# **South San Francisco Bay Shoreline Phase I Study**

## **Addendum No. 5 to the Final Environmental Impact Statement/ Environmental Impact Report**

May 11, 2021

Figure 5: Temporary alternative haul route along Grand Boulevard shown in yellow dashed line.

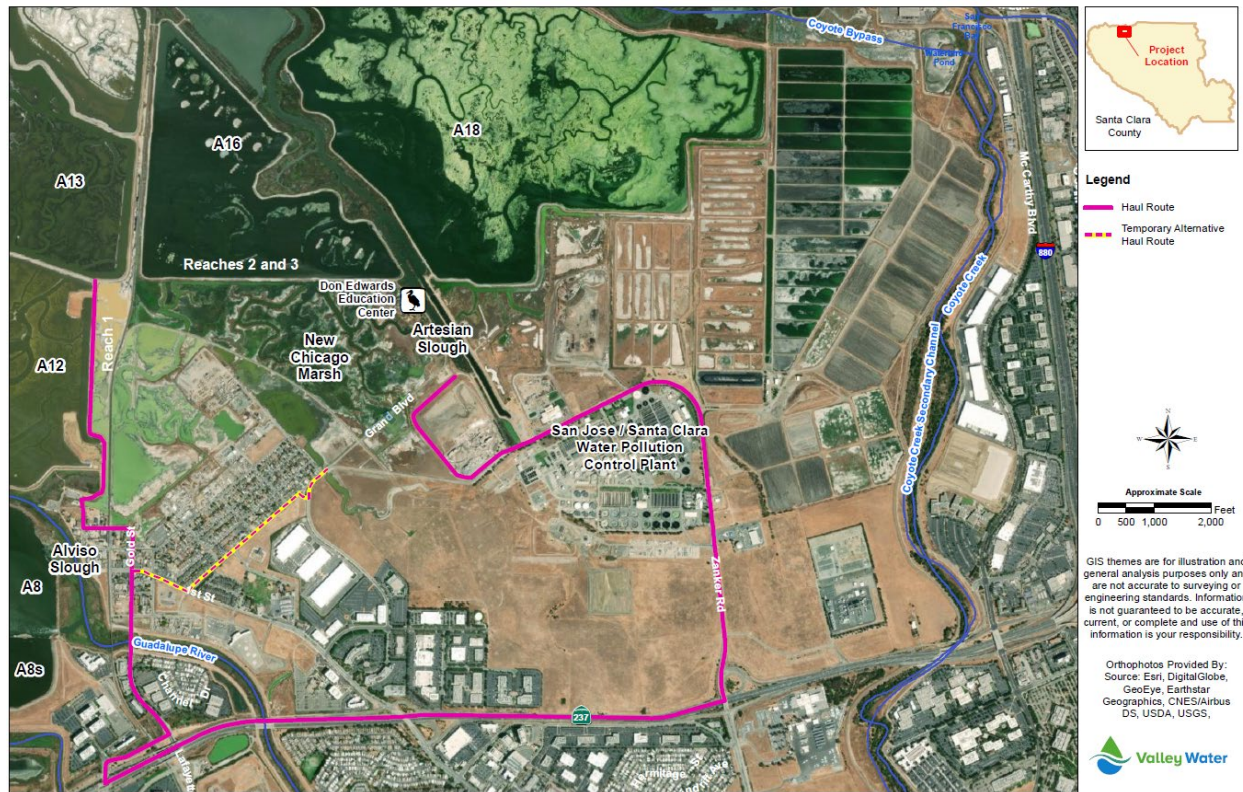
Subsequent to Addendum No. 4 which was prepared in November 2020, the USACE has identified an alternative haul route along Grand Boulevard that would shorten the travel distance between Reach 1 site at the Alviso Marina and Reaches 2 and 3 site at the Don Edwards San Francisco Bay National Wildlife Refuge Environmental Educational Center (EEC). Figure 5 shows a comparison between the previously approved and currently proposed routes.

As previously approved, construction vehicles would haul excavated material from Reaches 2 and 3 to Pond A12 in Reach 1 by following the path shown in Figure 4. The proposed modification to add an alternative haul route, which is shown in Figure 5, would allow contractors to drive approximately 0.65 miles on Grand Boulevard through a residential neighborhood for hauling of excavated material from Reaches 2 and 3 to Pond A12 in Reach 1. The inclusion of the proposed haul route segment along Grand Boulevard would give the contractor the option to use the alternative route during the decommissioning of the existing Reaches 2 to 3 levee, which would take 90 to 120 days to complete. Thus, the use of this alternative haul route would be limited to four months. Specifically, the project modifications would route the trucks from the Reach 1 site to south of Hope Street, left on Elizabeth Street to Gold Street, then left on North First Street to Grand Boulevard and on to the Reaches 2 to 3 site. The alternative haul route would also be used in reverse directions. This alternative haul route would reduce truck delivery time and hauling distance between Reaches 2 to 3 site and Pond A12.
